NOTICE: Revised Defect Information Notice – concerning Spindle Nuts and Stake Washer on certain ArvinMeritor TL Series trailer axles.

ArvinMeritor File: C11AB

NHTSA File: 10E-058

Procedures and Intervals to Inspect the Wheel Ends and Tighten the Spindle Nuts on Meritor TL Series Trailer Axles with Unitized Wheel Ends

Figure 3

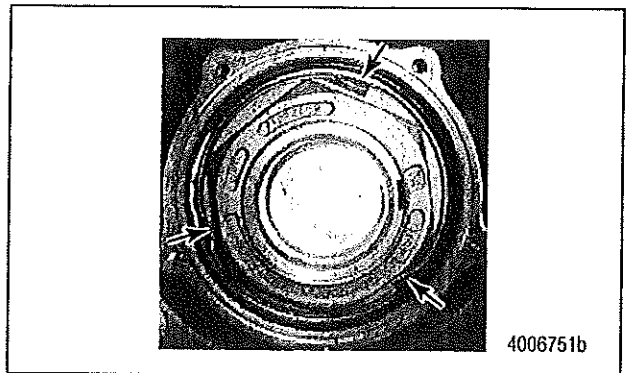
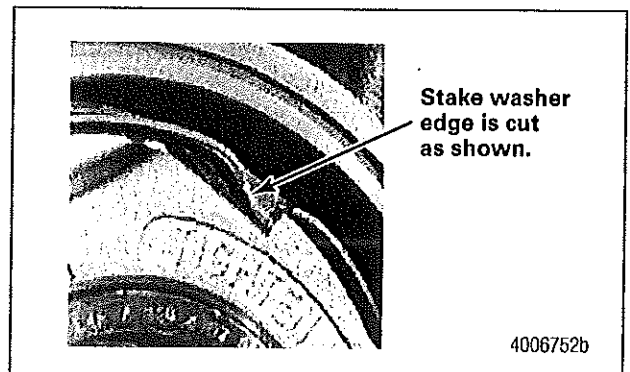
NOTE: You must stake the stake washer to the spindle nut in **three** positions.

9. Use a hammer and staking tool (Figure 13) to stake the stake washer to the spindle nut in **three** positions. Bend the washer to the stake profile as shown. Figure 3 and Figure 4.

Figure 9

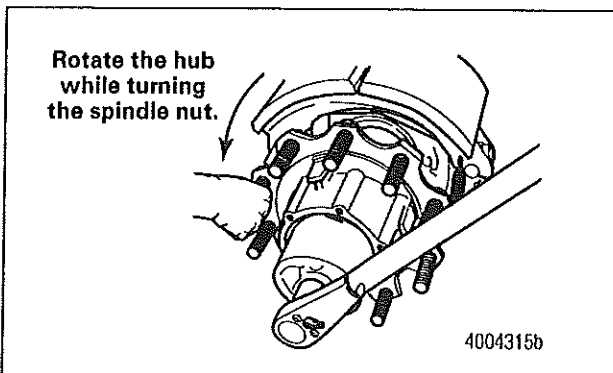
7. Tighten the spindle end nut to 810-850 lb-ft (1100-1150 N•m) while rotating the wheel and hub in a **COUNTERCLOCKWISE** direction. Do not back off the nut after tightening. Mark the location relative to the spindle. Figure 9. **ⓘ**

Figure 10

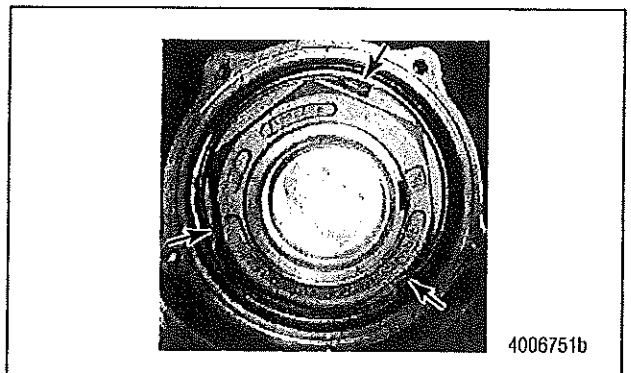
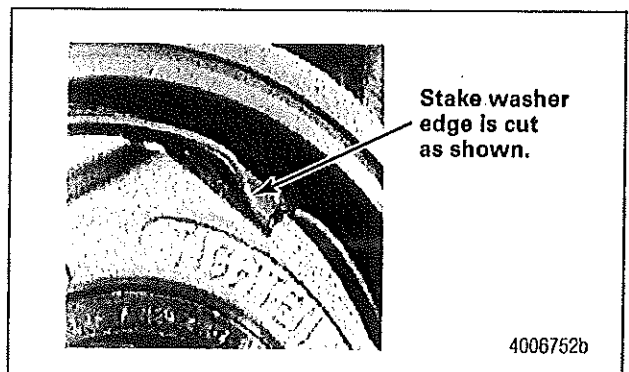
NOTE: You must stake the stake washer to the spindle nut in **three** positions.

9. Use a hammer and staking tool (Figure 13) to stake the stake washer to the spindle nut in **three** positions. Figure 10 and Figure 11.
